#### Airworthiness Directives; Bell Helicopter Textron Canada Model 407 Helicopters

**ACTION:** Notice of proposed rulemaking (NPRM).

**SUMMARY:** This document proposes superseding an existing airworthiness directive (AD) for Bell Helicopter

Figure 1. Preflight Check of the Tailboom

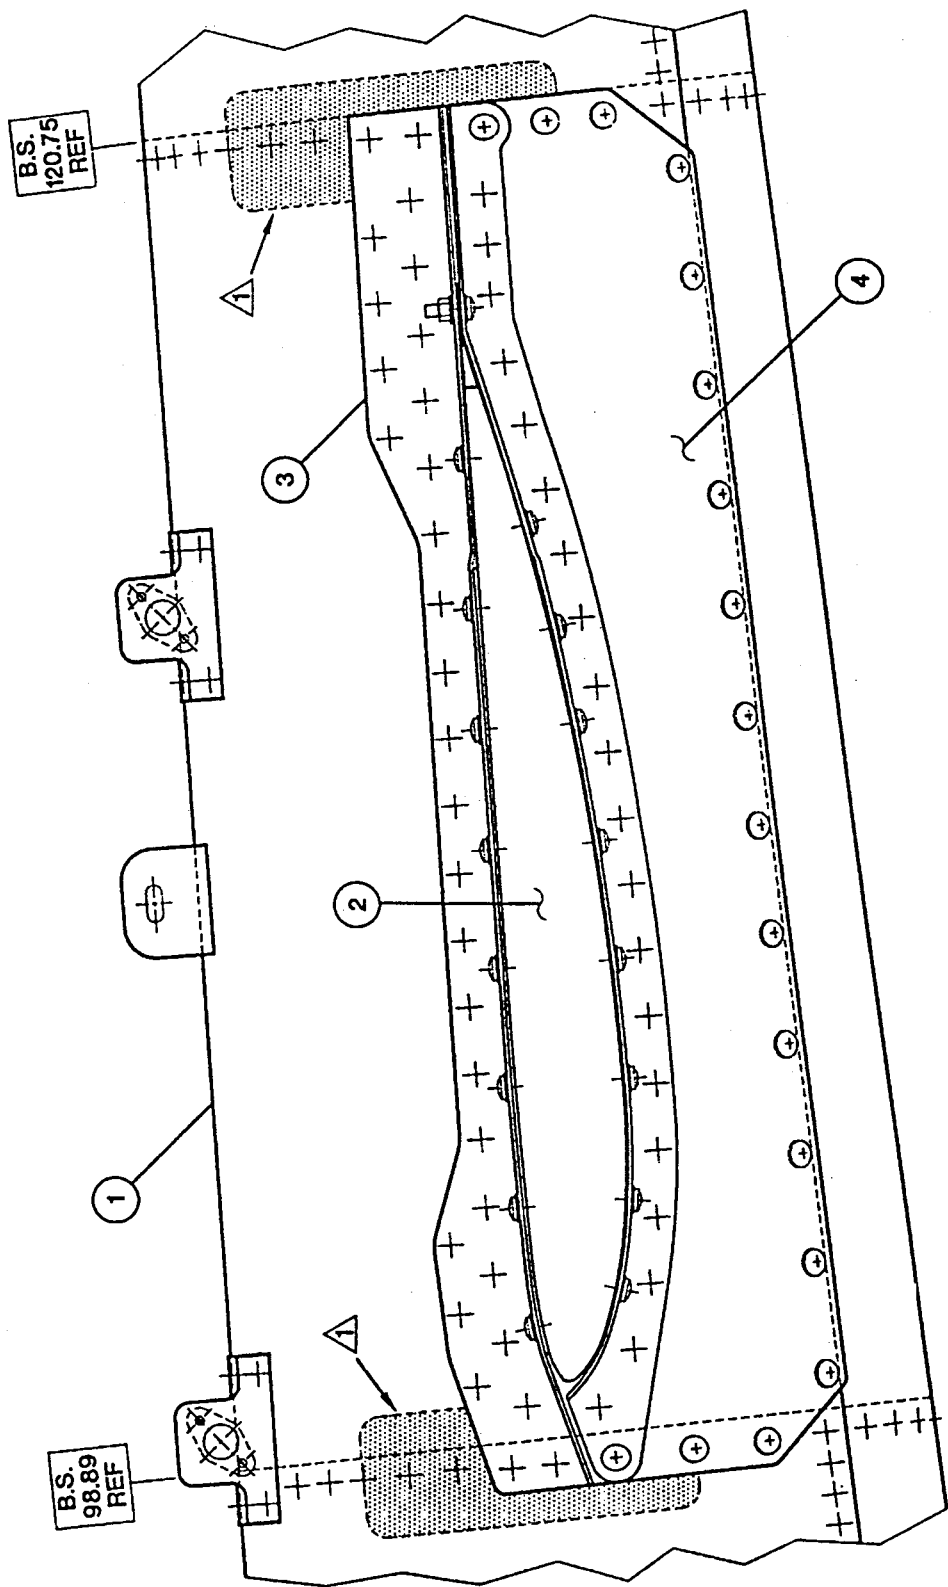
(a) Before further flight and thereafter before the first flight of each day, check the tailboom for a crack in accordance with Figure 1 of this AD. If a crack is found,

remove the tailboom before further flight. An owner/operator (pilot) holding at least a private pilot certificate may perform the visual check required by this paragraph but must enter compliance with this paragraph into the helicopter records in accordance with 14 CFR 43.11 and 91.417(a)(2)(v). A pilot can perform this check because it involves only a visual check for a crack in the tailboom and is a part of a normal pilot preflight check.

(b) Within 25 hours time-in-service (TIS) and thereafter at intervals not to exceed 50 hours TIS, visually inspect any tailboom with 600 or more hours TIS for a crack using a 10x or higher magnifying glass in accordance with the Accomplishment Instructions, Part II, of Bell Helicopter Textron Alert Service Bulletin ASB 407-99-26, Revision B, dated June 14, 2001, except you are not required to contact Bell Helicopter Product Support Engineering. If a crack is found, remove the tailboom before further flight.

(c) Installing a tailboom, P/N 407-030-801-201, is terminating action for the requirements of this AD.
